MACON HOTEL
682 CHERRY STREET
MACON, GEORGIA

Sheet Title:
Basement Plumbing Plan - Sewer

P1.0

1 BASEMENT PLUMBING PLAN - SEWER
SCALE: 1/4"=1'-0"

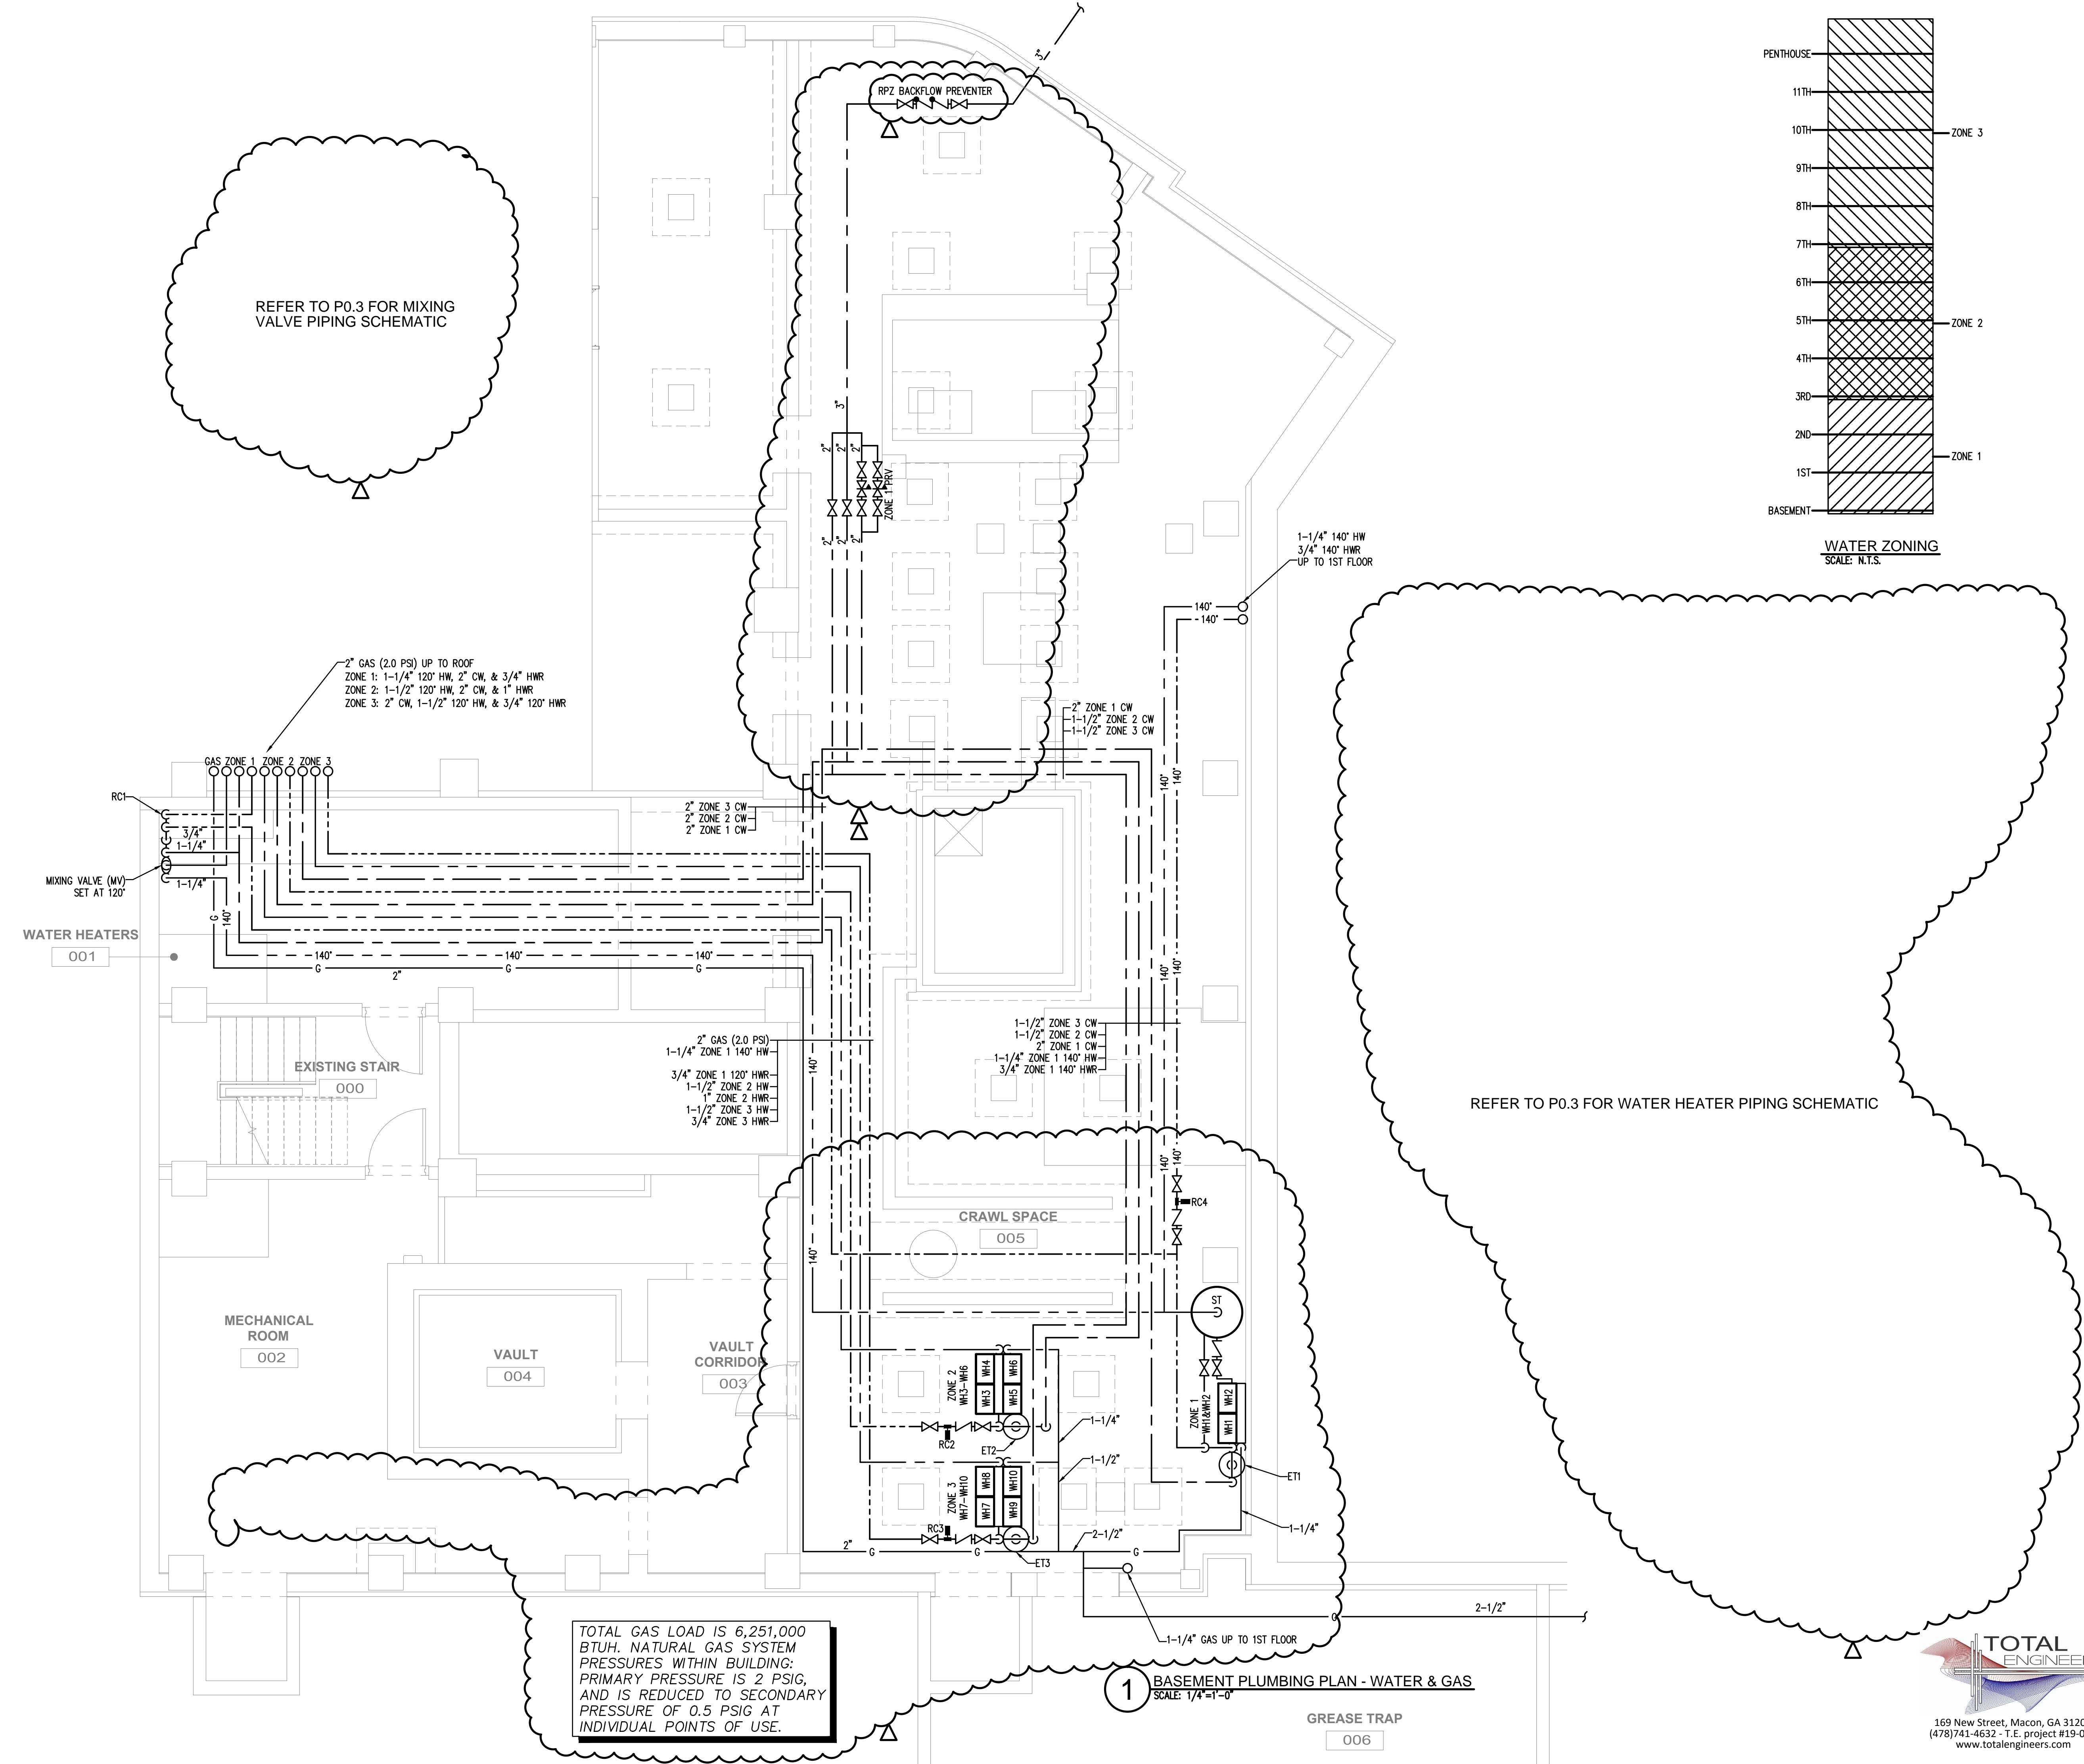
MWA COMMENTS:
GREASE TRAP SHALL BE ACCESSIBLE FOR ROUTINE PUMPING AND HAULING PURPOSES
